Portland Design Review Commission  
% Staci Monroe  
City of Portland Bureau of Development Services  
1900 SW Fourth Avenue  
Portland, Oregon

RE: LU 19-25732 DZM SWGW PC#19-198390; Alamo Manhattan Blocks

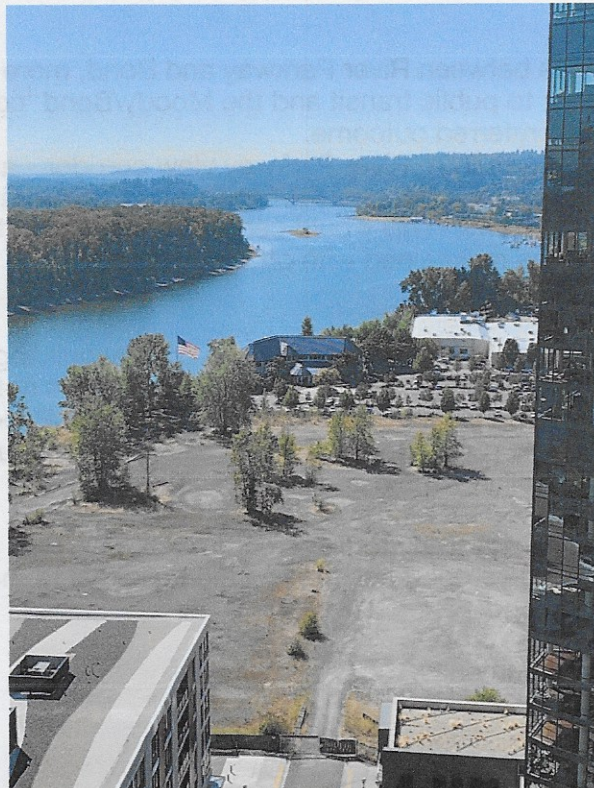
The pictures above illustrate the importance of River Parkway as a view corridor. The towers as currently planned, without any setbacks from River Parkway, would block the river view of hundreds of south facing units in the Atwater, Meriweather, the John Ross and Ardea almost entirely. The 'L' shape of the most southern tower makes this worse.

1. Move the towers to the blocks between River Parkway and Bond, more respectful of existing River views and closer to public transit and the Moody/Bond 'core.' I believe this would be the neighborhood's preferred outcome.
2. Alternatively, setback of the towers from River Parkway view corridor - along the lines of the Atwater Tower's setback. In other words, give the 'north-south' views as much consideration as the east-west views. This would certainly require substantial slimming of the towers. Unit count could be maintained with other approaches.
